ADDENDUM

PROJECT: University of South Dakota
Davidson Hall
Reroof
Vermillion, South Dakota

AD-1

DATE ISSUED: Wednesday, January 22, 2014

From Sheet:	A-101	for CA use:
Drawing #	A-101.1

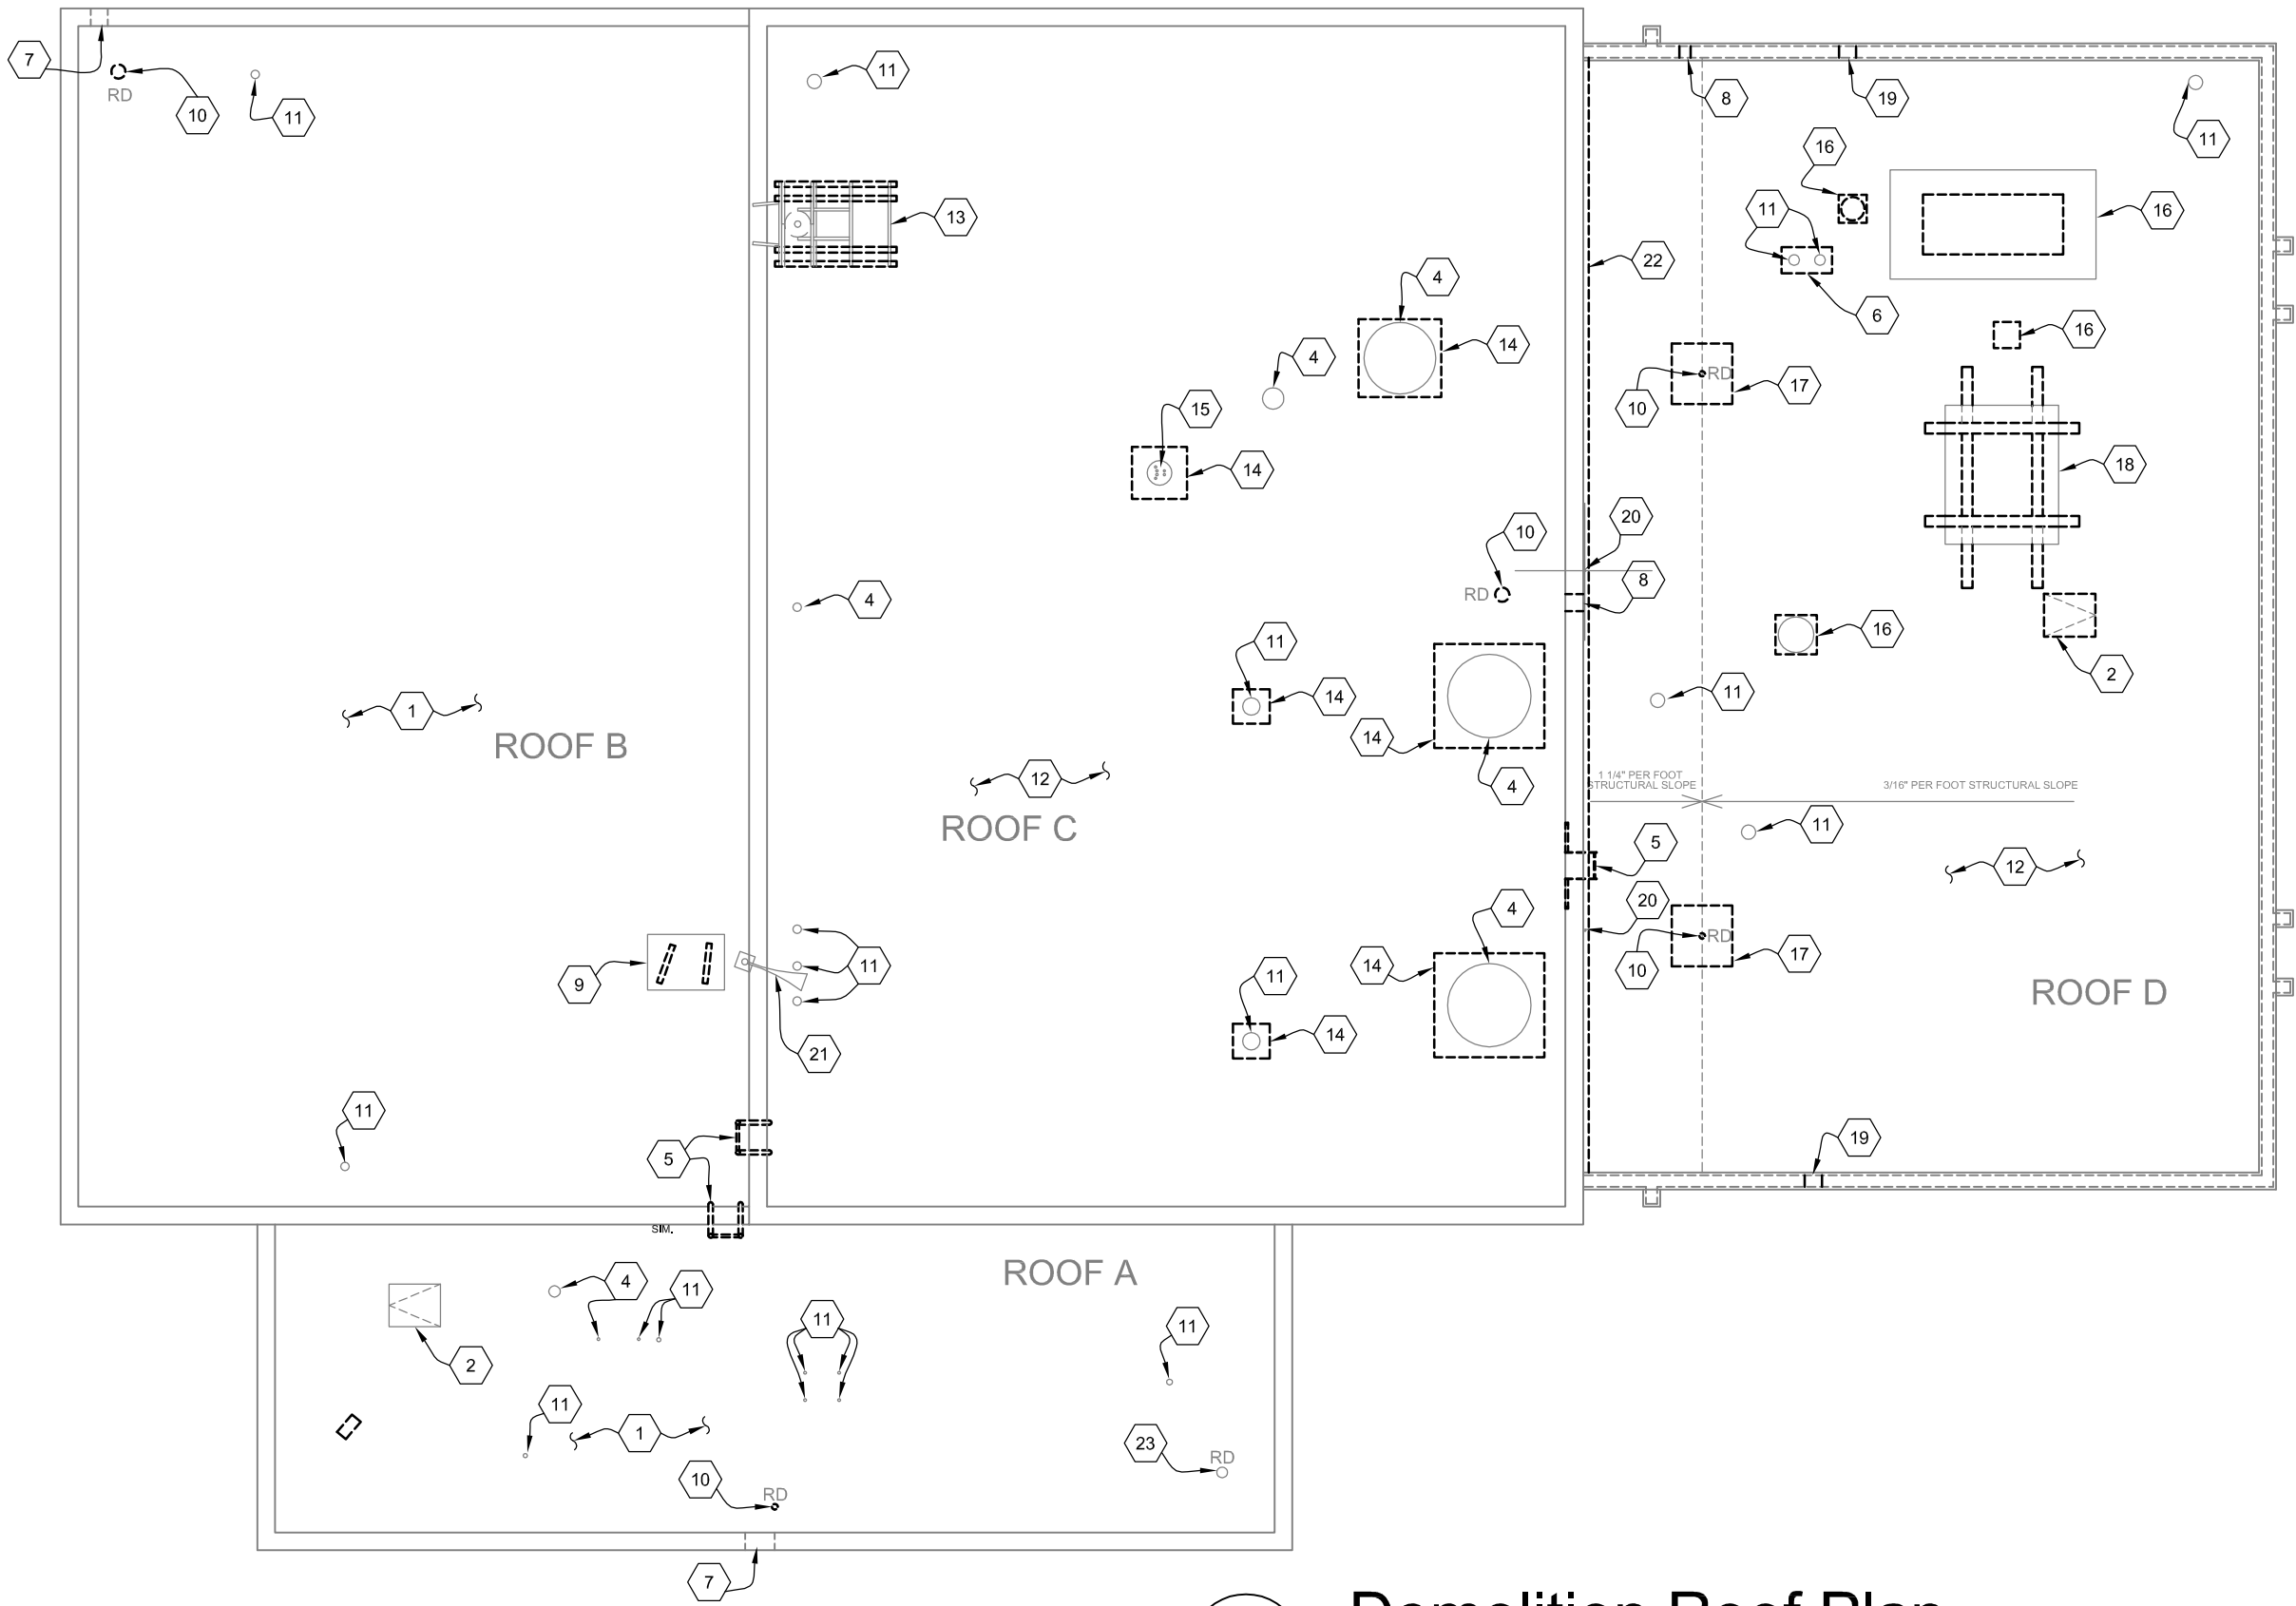
In reference to the Sheet A-101, replace Demolition Roof Plan 1/A-101 with the attached Supplemental Drawing A-101.1.
